APPLICATION NO.	FILING DATE	FIRST NAMED INVENTOR	ATTORNEY DOCKET NO.	CONFIRMATION NO.
09/616,638	07/26/2000	Percy Bennwik	10806-109	8709

Office Action Summary

DETAILED ACTION

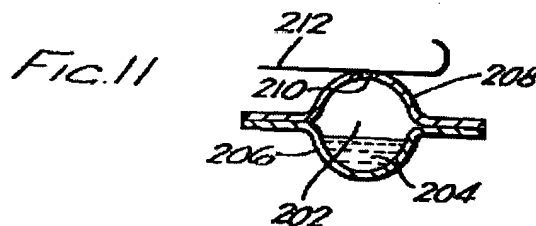
Regarding claim 1, Scherer teaches a pressurisable container for storing and ejecting liquid (204), the container comprising a front wall (208) having or surrounding a cavity (202) corresponding to the form of an open vessel, an opening (210) in the front wall (208) adapted of ejection of the liquid (204) from the container, said opening (210) defining a container axis, optionally a sealing (212) over the opening (210) adapted for temporary use, and a rear wall (206) closing and sealing the open part of the front wall (208) vessel to confine a space for the liquid (204) in the container, the rear wall (206) running at least partially perpendicular to the container axis and being displaceable or deformable for movement towards the opening to pressurize the container liquid (204), wherein the front wall (208) is substantially rigid in relation to the rear wall (206), the rear wall (206) before pressurizing the container is substantially flat or substantially single curved, and the rear wall (206) is deformable under stretching to substantially fill out the container cavity (202)(see Fig. 11, below).

Regarding claim 2, see Fig. 11, above.

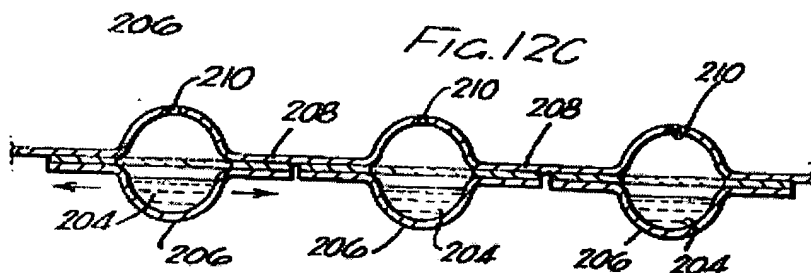
Regarding claims 14-17, see Fig. 12C, below.

Regarding claim 20, 21, 24 and 28, see Fig. 12C, above.

Regarding claim 40, Scherer teaches a rear wall (206) attached to the rear surface of a front wall (208)(see Fig. 12 C, above).

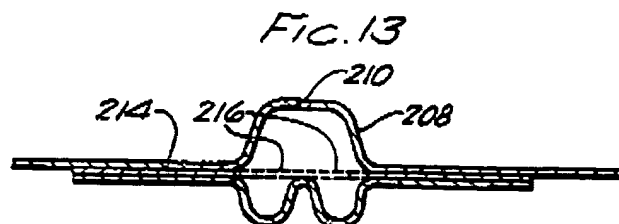
Regarding claim 27, see Fig. 13, below.

Regarding claim 92, Scherer teaches device comprising a ram (see Fig. 13).

**FIG. 3****FIG. 4**

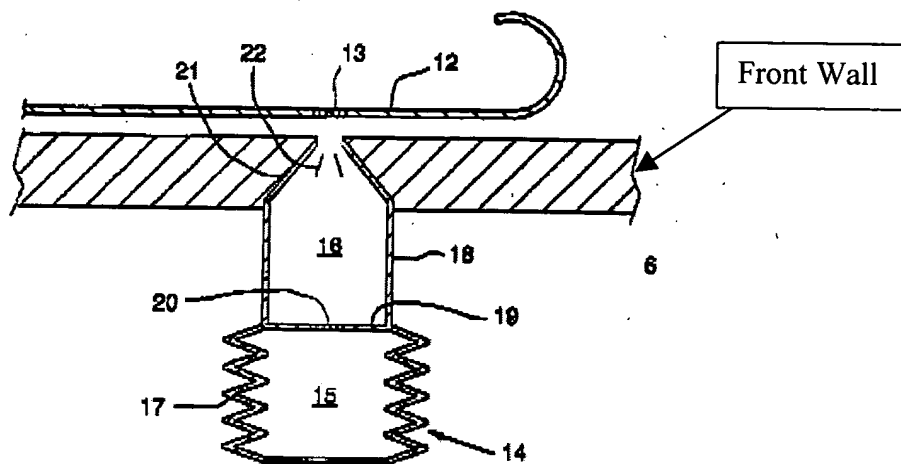
Lloyd *et al.* teach a pressurisable container (16) for storing and ejecting liquid, the container (16) comprising a front wall having or surrounding a cavity corresponding to the form of an open vessel, an opening (13) in the front wall (208) adapted of ejection of the liquid from the container, said opening (13) defining a container axis, optionally a sealing (12) over the opening (13) adapted for temporary use, and a rear wall (14) closing and sealing the open part of the front wall vessel to confine a space for the liquid in the container (16), the rear wall (14) running at least partially perpendicular to the container axis and being displaceable or deformable for movement towards the opening (13) to pressurize the container liquid, wherein the front wall is substantially rigid in relation to the rear wall (14), the rear wall (14) before pressurizing the container is substantially flat or substantially single curved, and the rear wall (14) is deformable under stretching to substantially fill out the container cavity, wherein the front wall has a thickness that increases away from the axis (see Fig. 3, below).

Regarding claim 21, see Fig. 3, below.

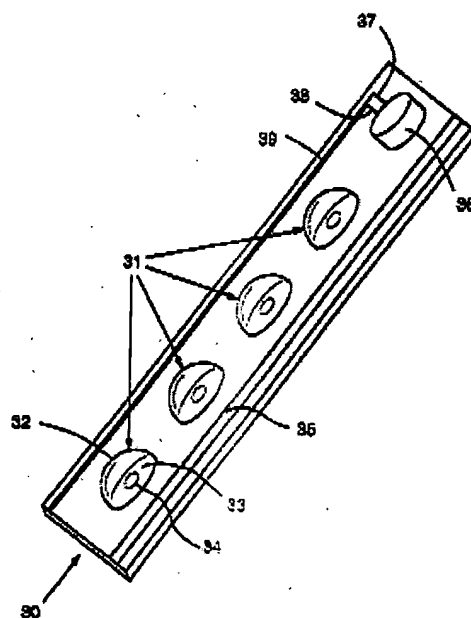
Regarding claims 14, 18, 20 and 42, see Fig. 4, below.

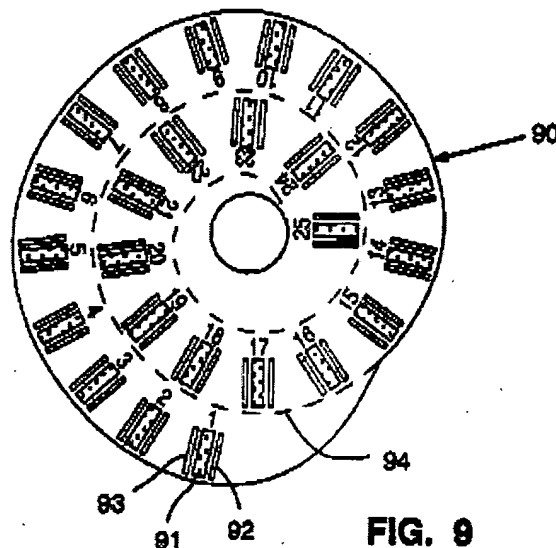
Regarding claims 22 and 23, see Fig. 9, below.

Regarding claims 24 and 25, Lloyd *et al.* teach a front wall (90) comprising a partial cylinder (e.g., the end portion of a cylinder)(see Fig. 9, below).

Regarding claim 26, Lloyd et al. teach several containers (91) positioned over two dimensions of the cylinder surface (see Fig. 9, below).

Regarding claim 69, see Fig. 9, above.

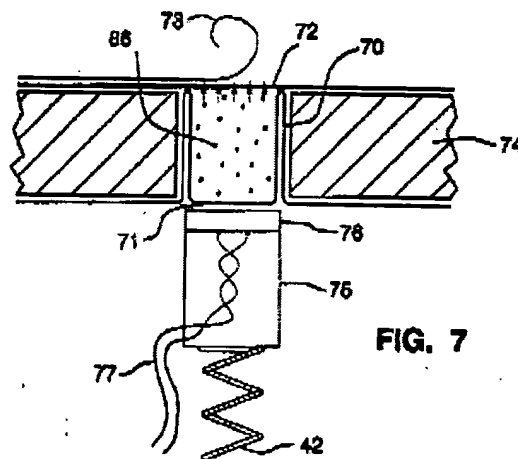
Regarding claim 75, see Fig. 7, below.

Regarding claims 77 and 78, see Fig. 7.
